AR7030 SYNCHRONOUS AM

PART OF AR7030 PCB SHOWING ADDITIONAL THERMISTOR & 150K ADDED BETWEEN R143 / C134 AND THERMISTOR & 47K ADDED BETWEEN R135 / C107.

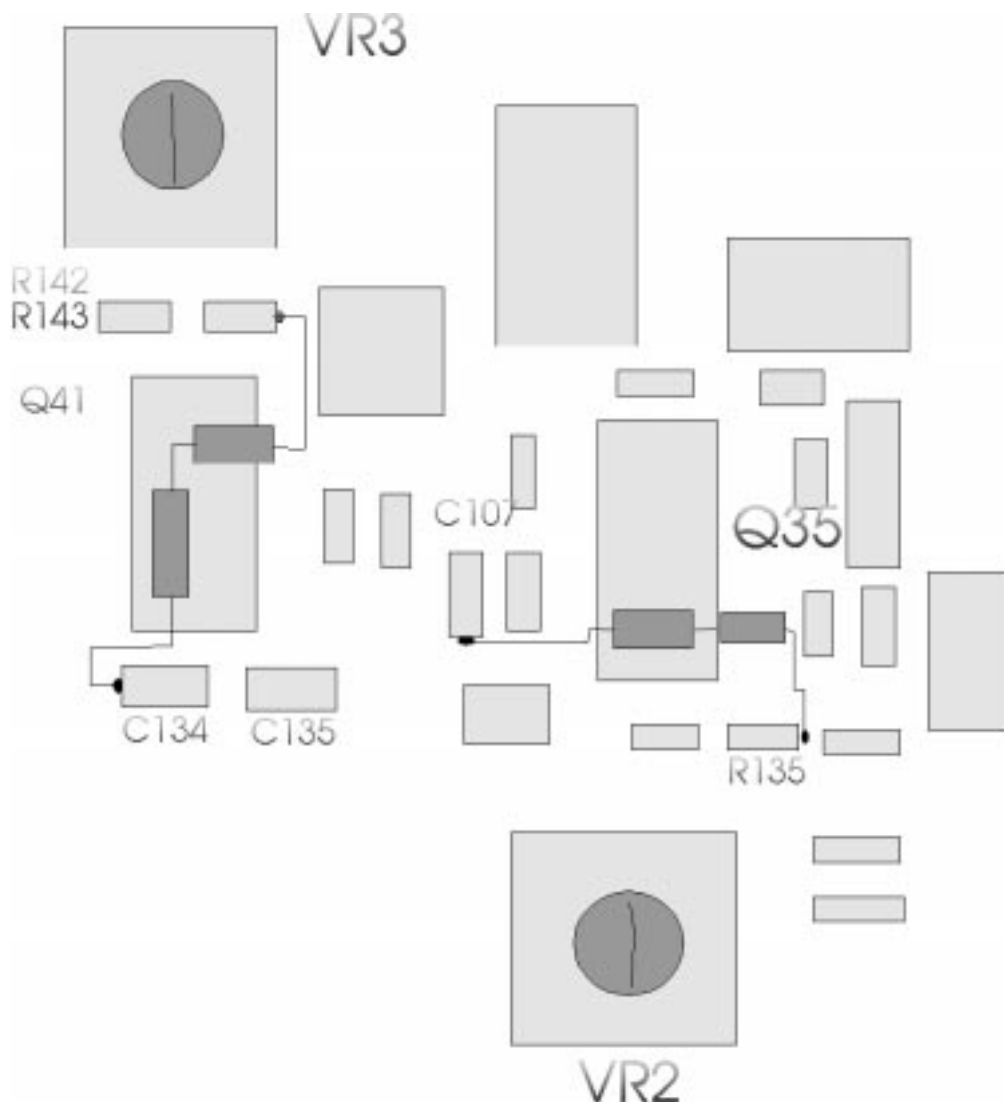
To do this, simply add a resistor and thermistor in parallel with VR2.
The thermistor used is a NTC 100K (@25C), RS 198-961.
The resistor is added in series with the thermistor is 47K.

The 47K res' should be placed vertically up from the VR2 end of R135.
Solder the thermistor so that it goes from the spare end of the 47K to a suitable earth point (earth end of C107). Place the bead of the thermistor so that it rests on Q35.

Add a 100K @ 25C (RS 198-961) thermistor in series with a 150Kohm resistor from the junction of VR3 / R143 up to a suitable 5V supply level (one end of C134). Place the thermistor on to the top of Q41.

In the first case, the 47K should be replaced with a 100K and a further 100K will have to be added in parallel with the thermistor.

In the second case, the 150K should be replaced with 120K and a further 15K will have to be added in series with this (making 135K in total).
